479-2024 ADDENDUM 03

JESSIE FLOOD PUMPING STATION (FPS) 2024 UPGRADES

ISSUED: July 25, 2024
BY: Mark Baker, P.Eng.
TELEPHONE NO. 204-688-3805

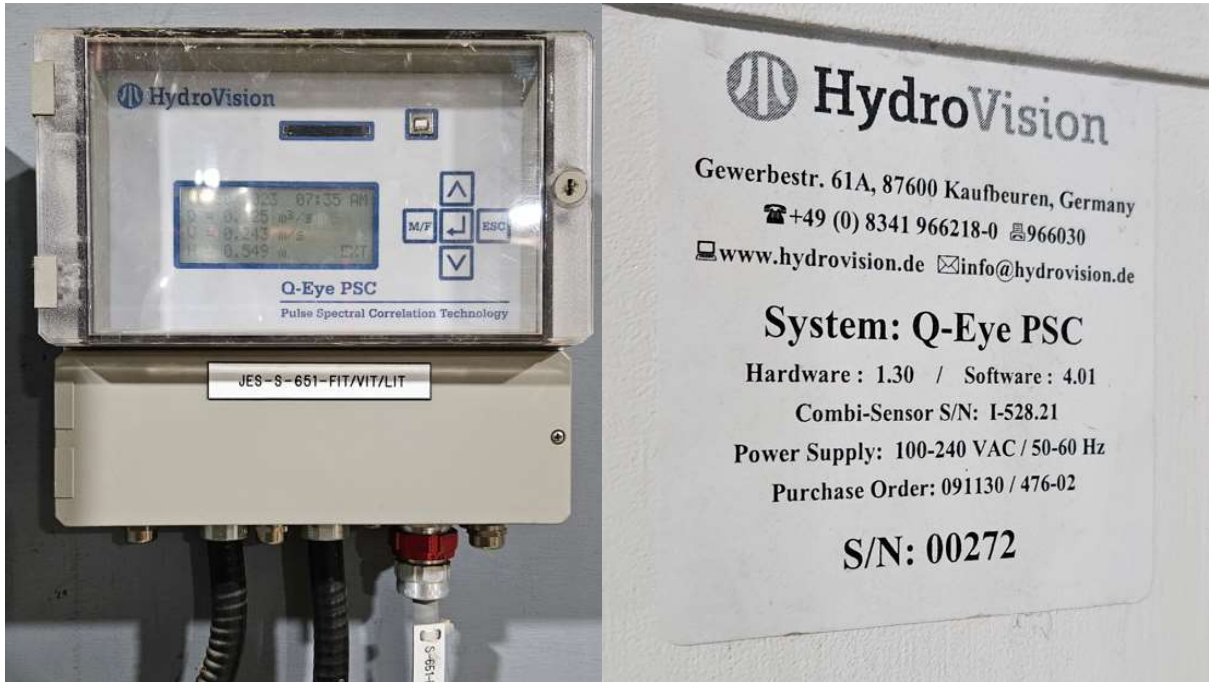
Q1: What is the serial no of existing GWF Q-Eye PSC Transmitter (Tag FIT-S651/VITS651) under drawing 1-0149F-A0047-001-00?

A1:
